**GENOA CHARTER TOWNSHIP  
PLANNING COMMISSION  
SPECIAL MEETING AND PUBLIC HEARING  
FEBRUARY 13, 2024  
TUESDAY  
6:30 P.M.  
AGENDA**

<b>Attention:</b>	Amy Ruthig, Planning Director
<b>Subject:</b>	Soapy Bucket Car Wash – Site Plan Review #3
<b>Location:</b>	1415 Lawson Drive – southwest corner of Grand River Avenue and Lawson Drive
<b>Zoning:</b>	NRPUD Non-Residential Planned Unit Development

**Re: Soapy Bucket Car Wash  
Site Plan Review No. 3**

TITLE: SITE PLAN

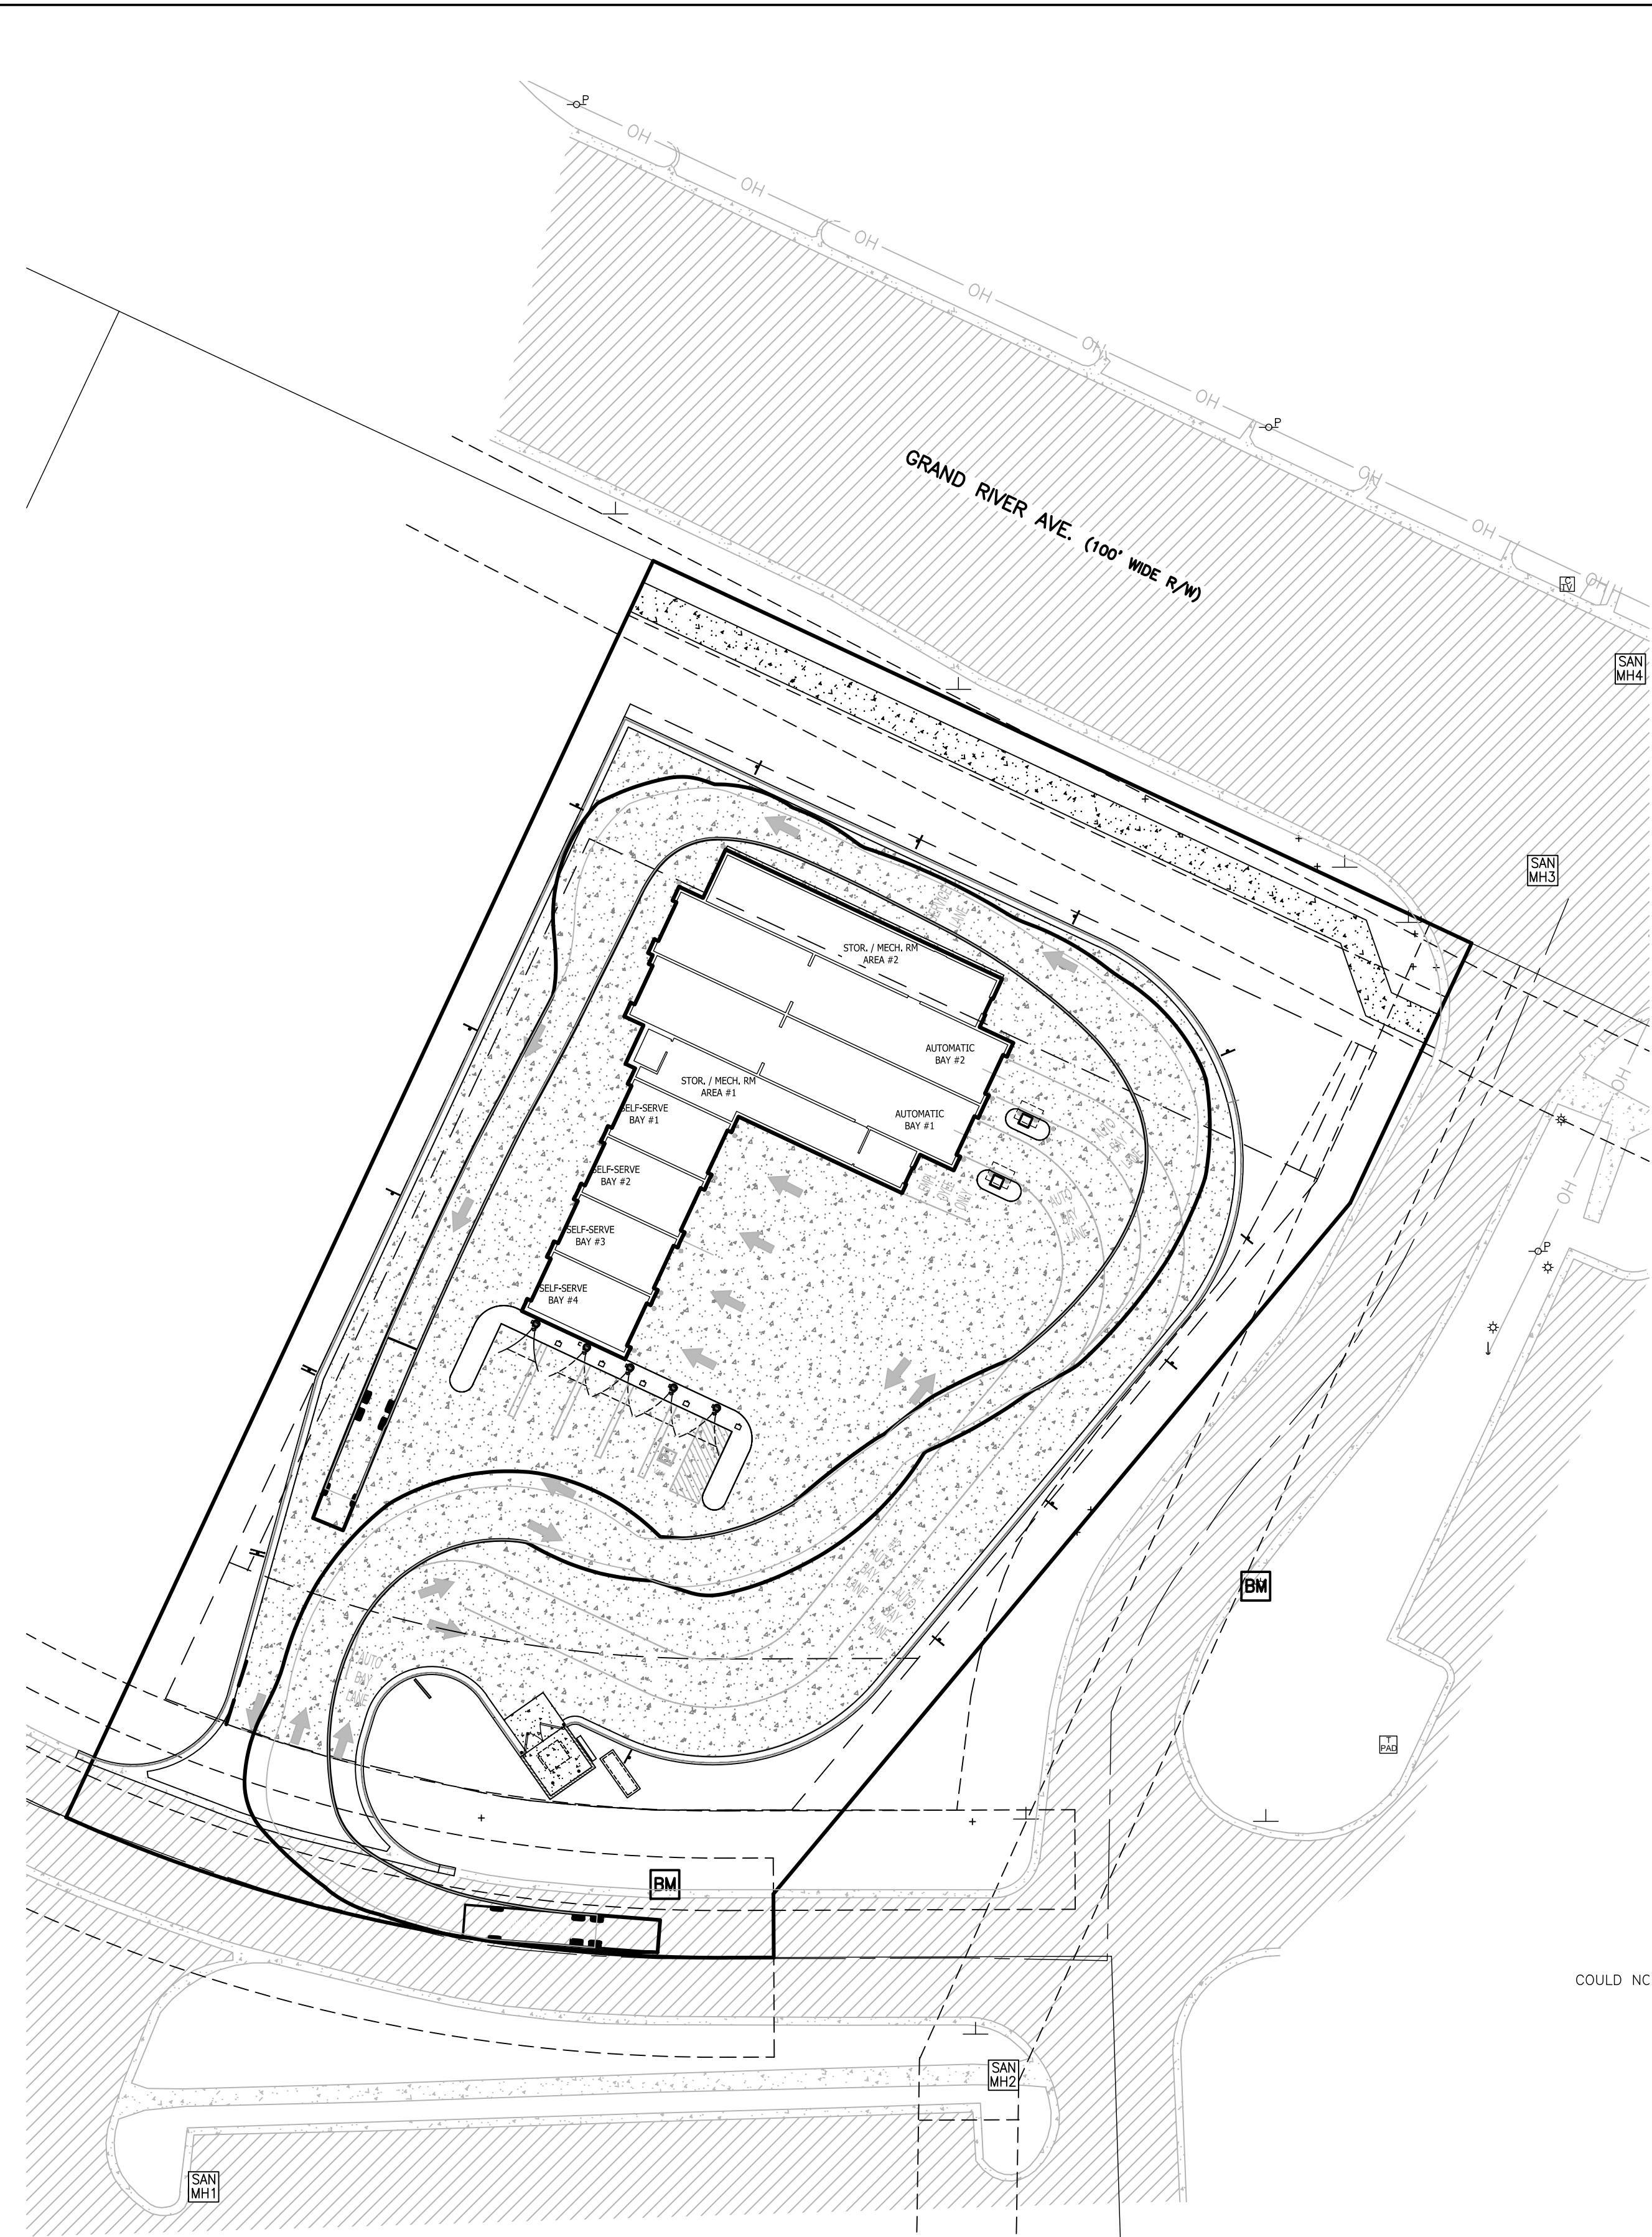
The site plan depicts 1 ingress/egress driveway to/from Lawson Drive on the south side of the site.

The revised building orientation provides compliant stacking for each wash bay (automatic and self-service).

The previous submittal included blue vacuum stations. The cover letter included with the revised submittal notes that the blue color has been changed, though there is no indication of the newly proposed color.

- 3. Pedestrian Circulation.** The site plan proposes an 8-foot wide concrete sidewalk along Grand River, as required.
- 4. Vehicular Circulation.** The site plan proposes 1 curb cut for a full turning movement driveway along Lawson Drive.

The revised building orientation mitigates the stacking deficiency of previous submittals, which will help to prevent back-ups into Lawson Drive.

- 5. Parking.** Based on information contained in the submittal, the project requires 3 parking spaces. The site plan provides 6 parking spaces (5 of which double as vacuum stations), including the required barrier-free space.
